**Research Reactor Center**

REFERENCE: Docket No. 50-186
University of Missouri-Columbia Research Reactor
Renewed Facility Operating License No. R-103

SUBJECT: Written communication as specified by 10 CFR § 50.4(b)(1) requesting U.S.
Nuclear Regulatory Commission approval to revise the Technical
Specifications appended to Renewed Facility Operating License No. R-103
pursuant to 10 CFR § 50.90

FIGURE 1
SRDM (green paint) Bolted and Installed on the Offset Mechanism Upper Housing (no paint)

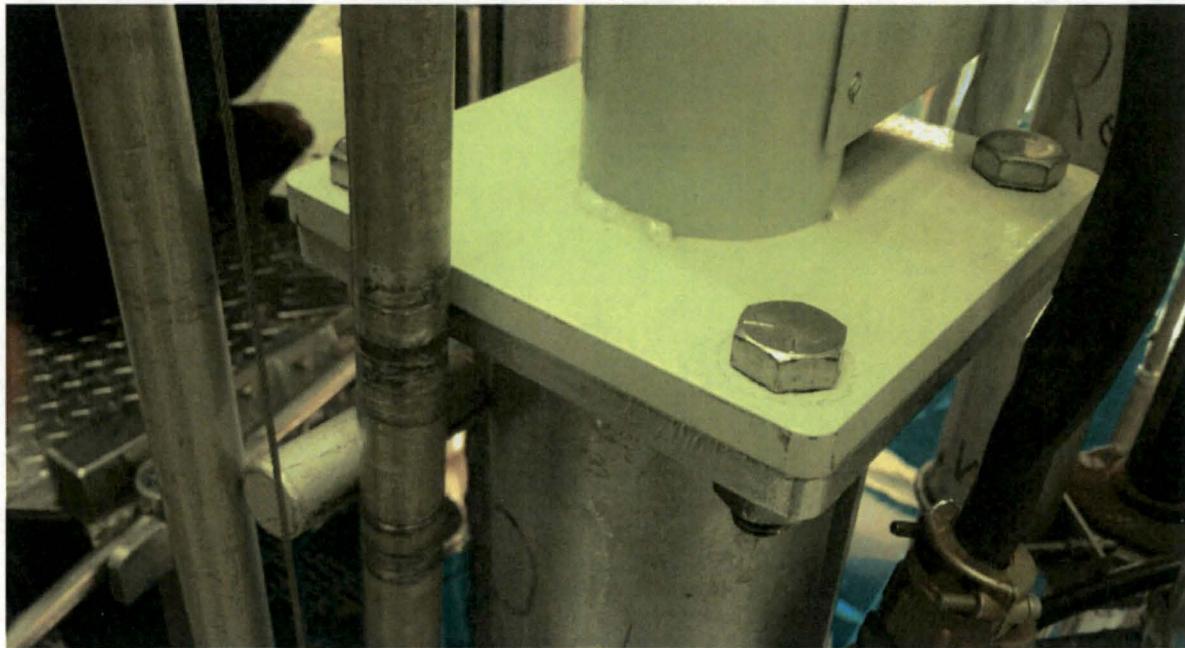
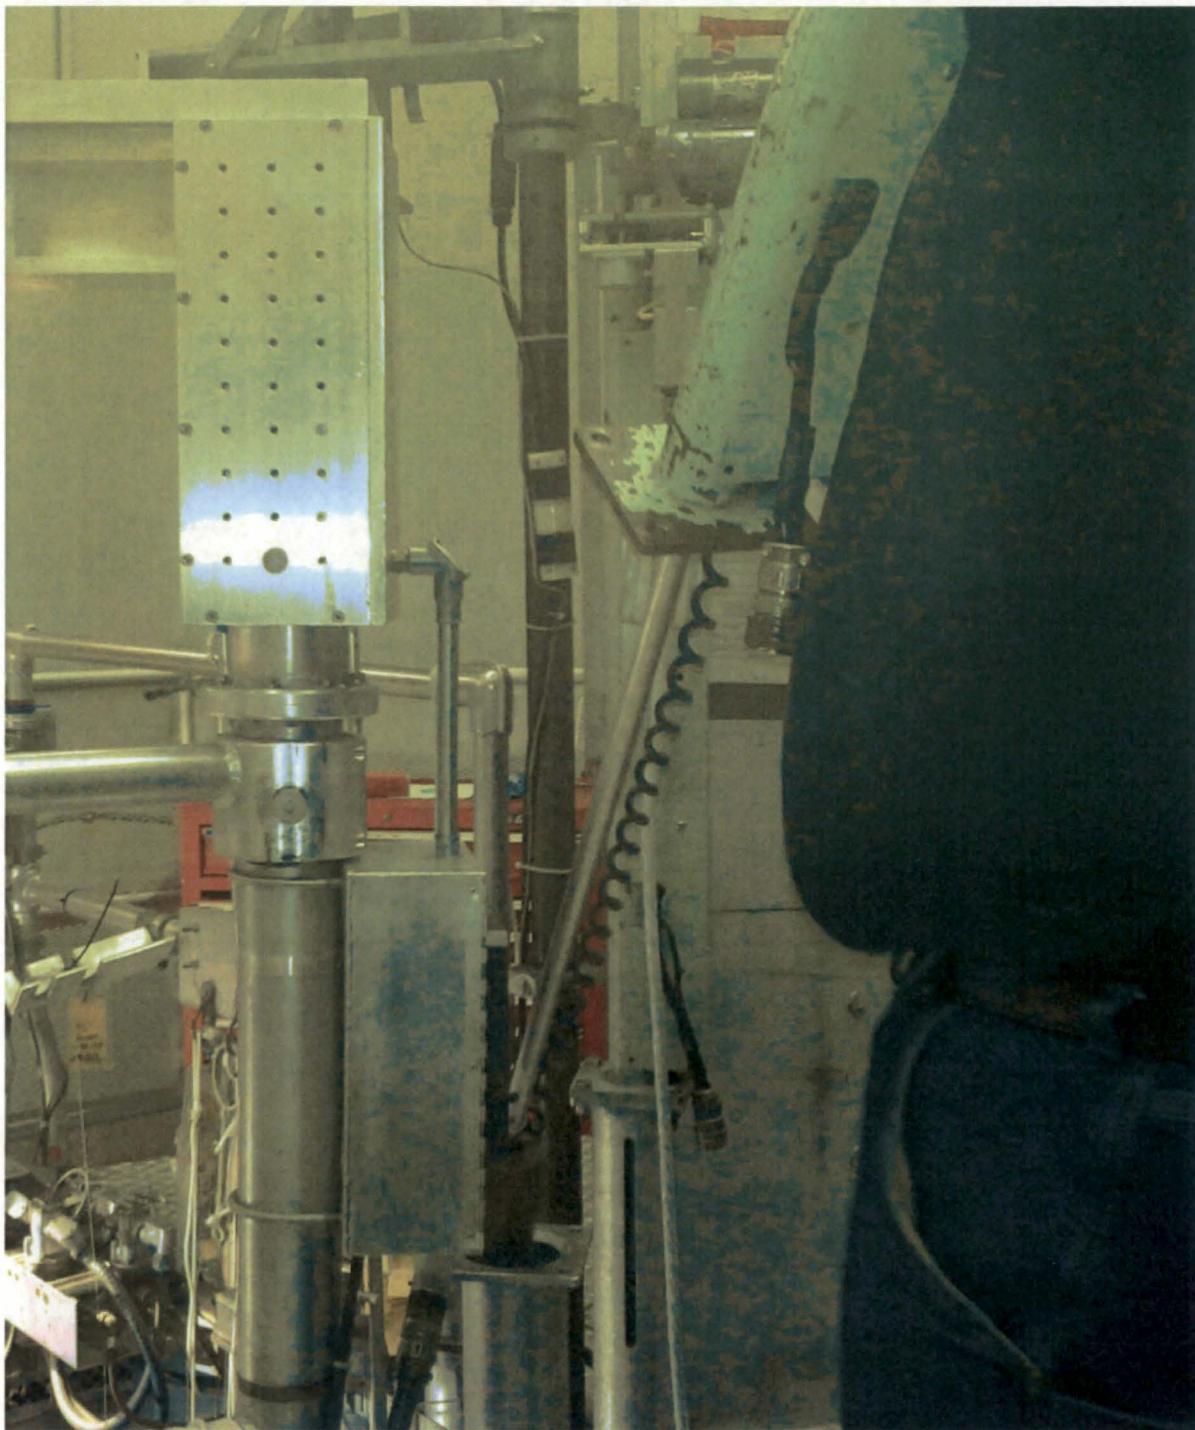
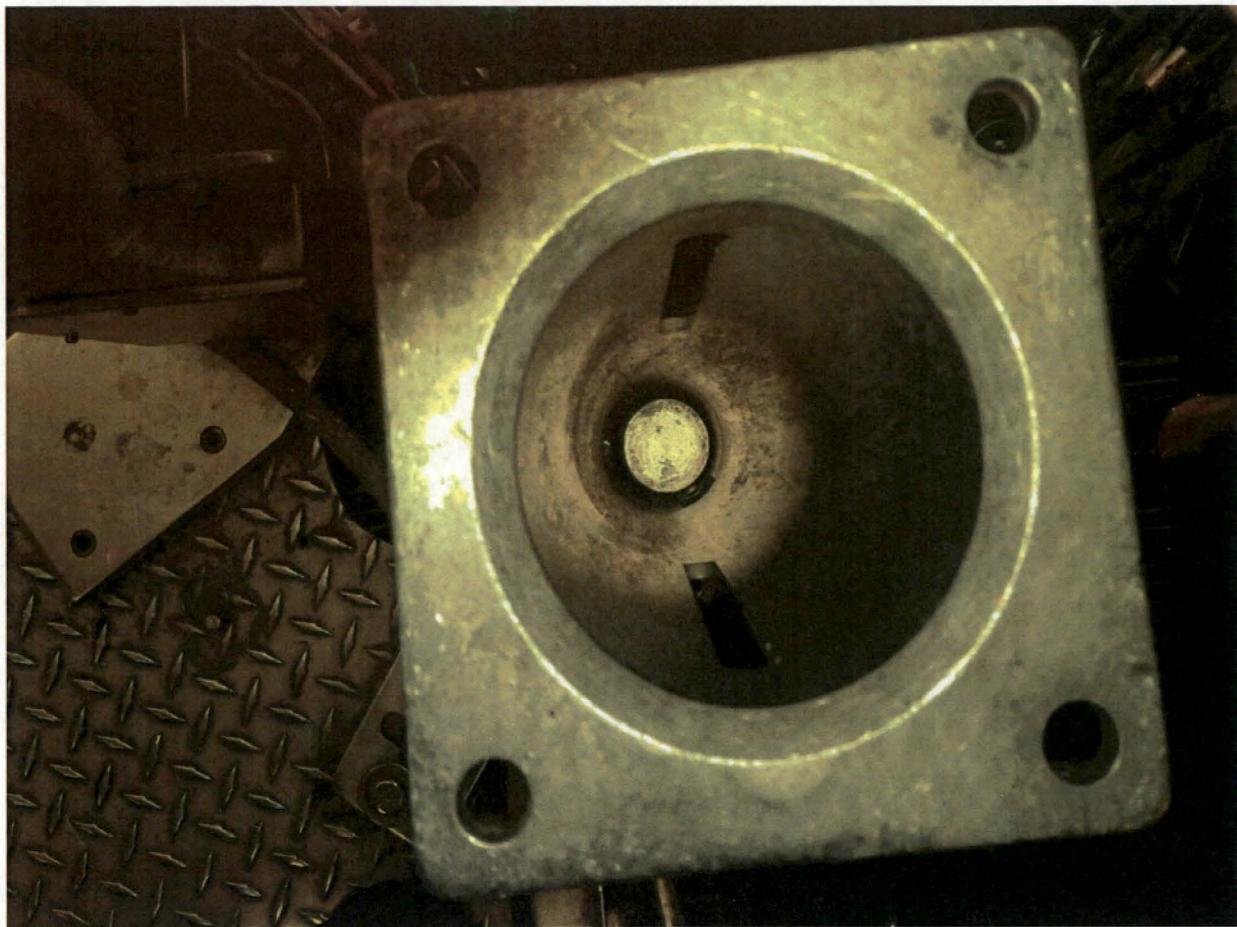
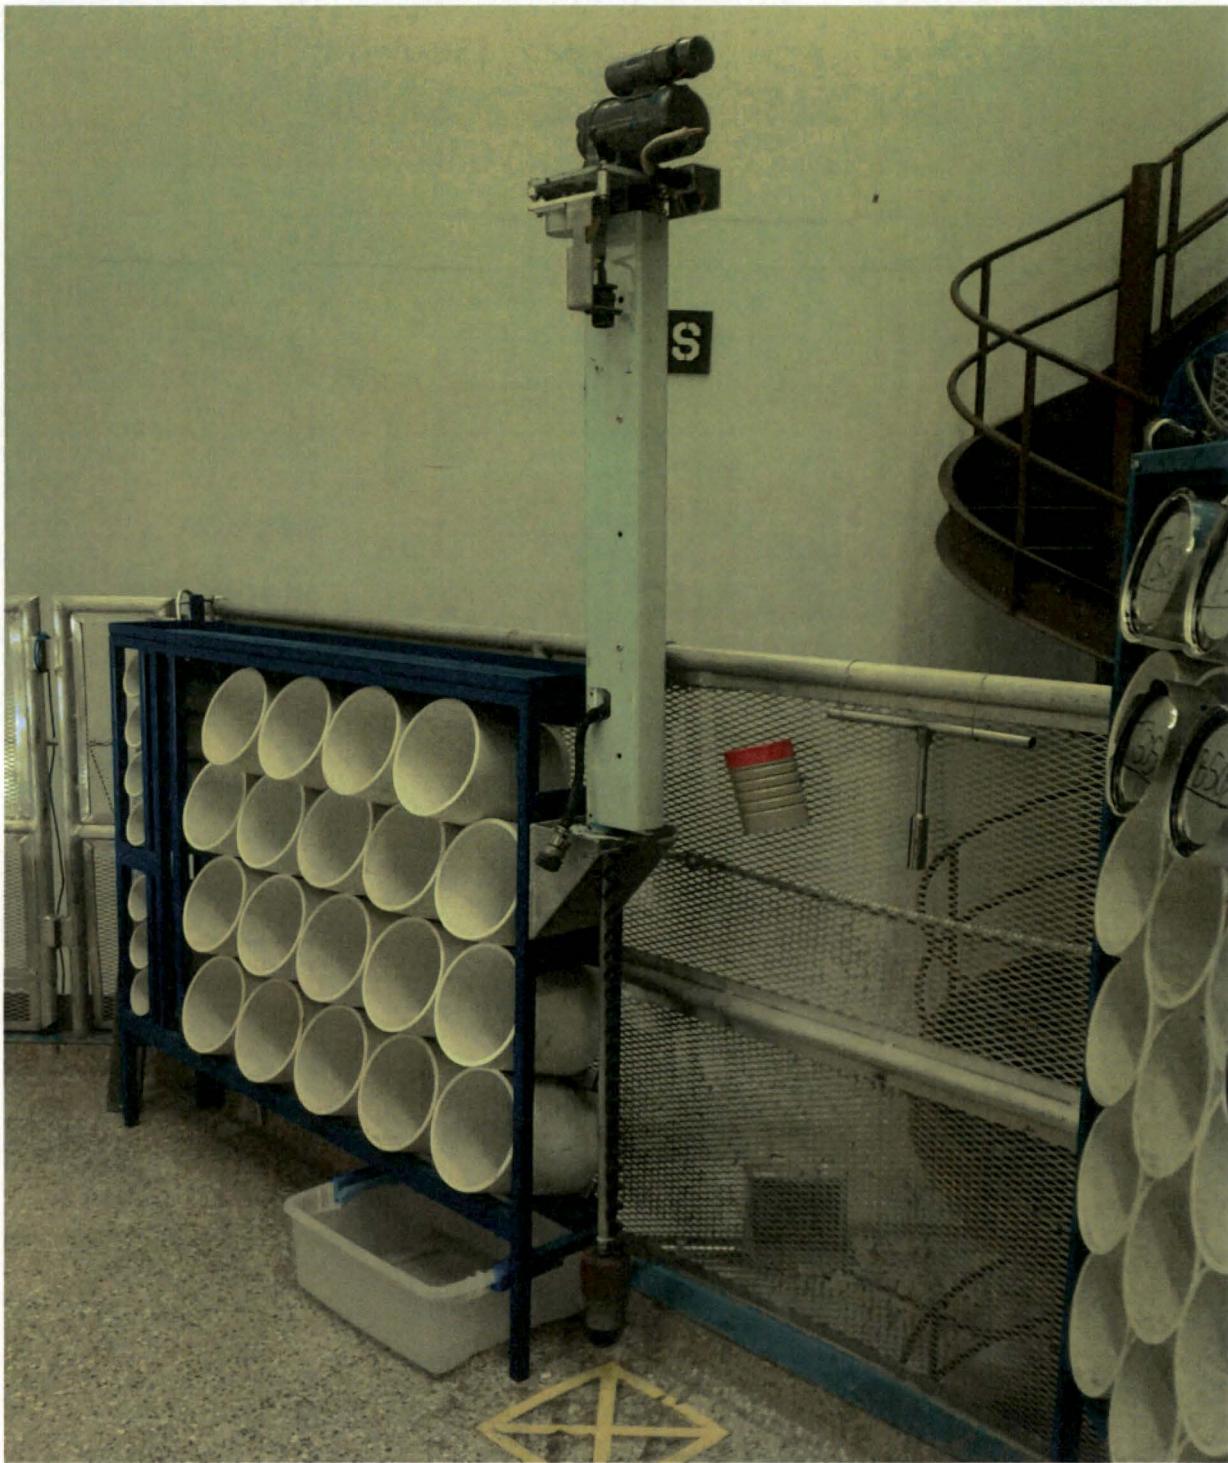
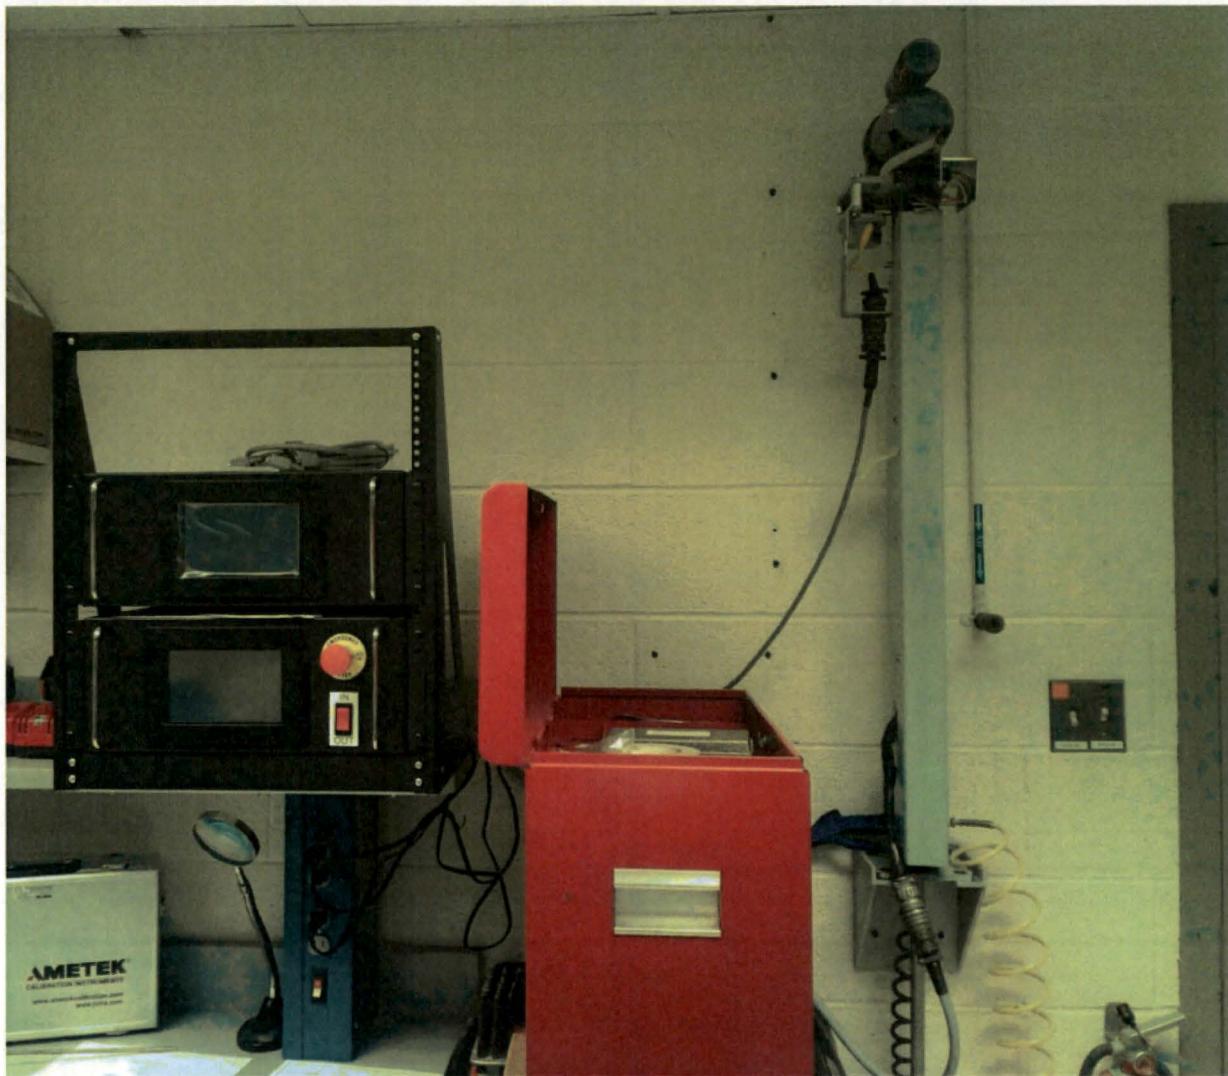
As can be seen in the photographs and discussed in Section 4.4.4.2 of the MURR SAR, the only component that physically couples the SRDM to a shim control blade is an energized electromagnet. If the SRDM is electrically disconnected so that no electrical current can flow through the SRDM electromagnet, that SRDM can no longer change the position of its shim control blade – it is physically decoupled from the control blade even if the SRDM is installed in its offset mechanism upper housing. Furthermore, uninstalling (or removing) the SRDM from the offset mechanism upper housing provides an additional barrier that ensures the decoupling of the SRDM from its associated shim control blade. Therefore, TS 1.26, “Reactor Secured,” can be revised as proposed below to allow for work to be performed on uninstalled and physically decoupled SRDMs.

Specification 1.26 will be revised as follows:

Containment Building Leak Rate Historical Data (in SCFM) – Calendar Years 2007 to 2019

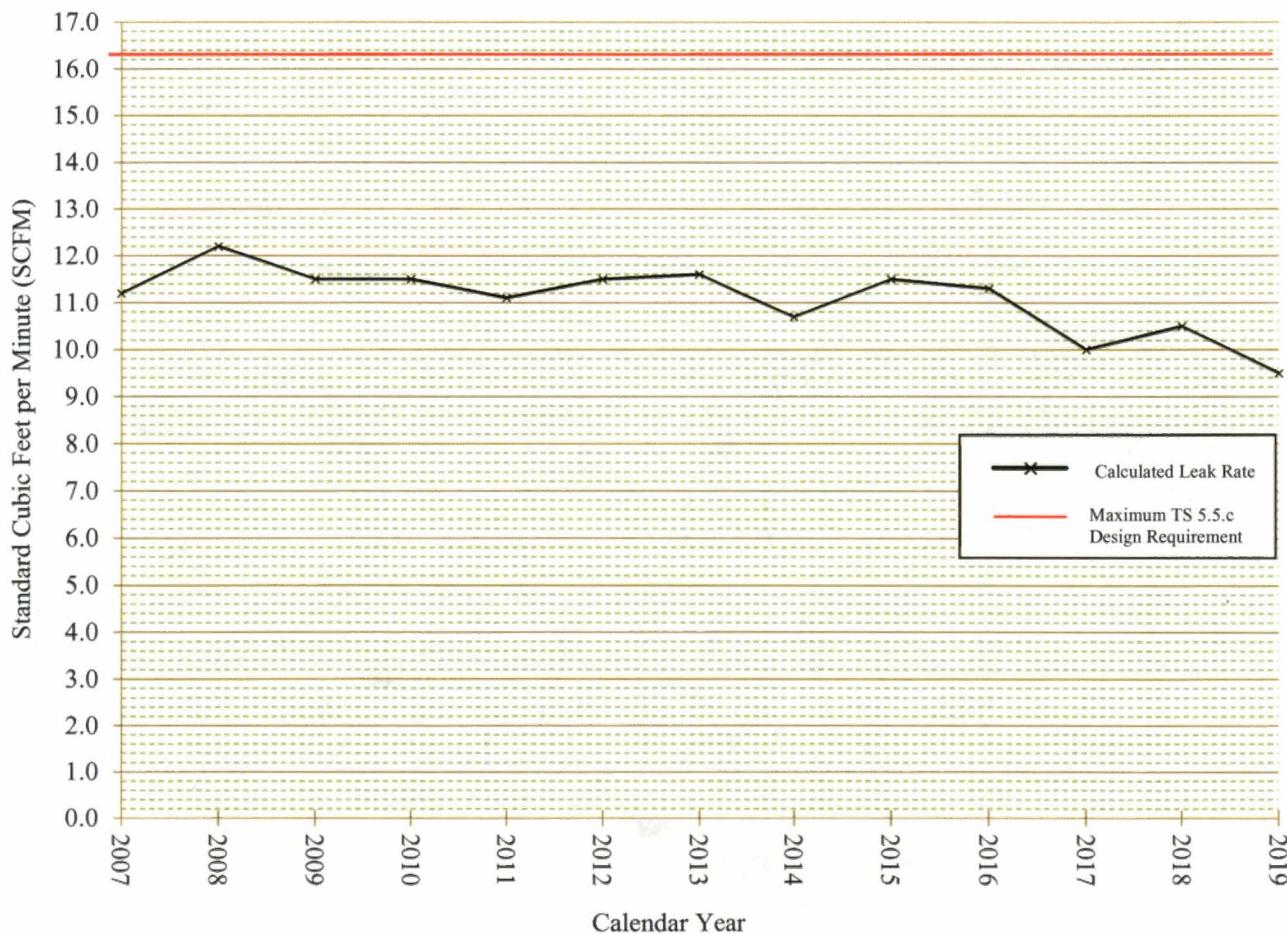
From 1978 through 2006, the average reactor containment building leakage rate was 8.1 standard cubic feet per minute (SCFM), and there was some variance through the years as MURR used different pressure and humidity instruments, as well as converting from a 1980s VAX computer program to using Microsoft Excel. Since 2007, the MURR process, software, and instrumentation used for measuring containment building leakage rate have been very consistent. Leakage rate values from 2007 to 2019 range from 9.5 to 12.2 SCFM, well below the Specification 5.5.c design requirement of 16.3 SCFM – see graph below. The red horizontal line at the top of the graph designates the TS leakage rate limit of 16.3 SCFM at a containment building pressure of 1.0 psig.

- “a. The reactor containment building leakage rate shall be measured biennially. The test shall be performed by the make-up flow, pressure decay, or reference volume techniques. No repairs or modifications shall be performed just prior to the test.”
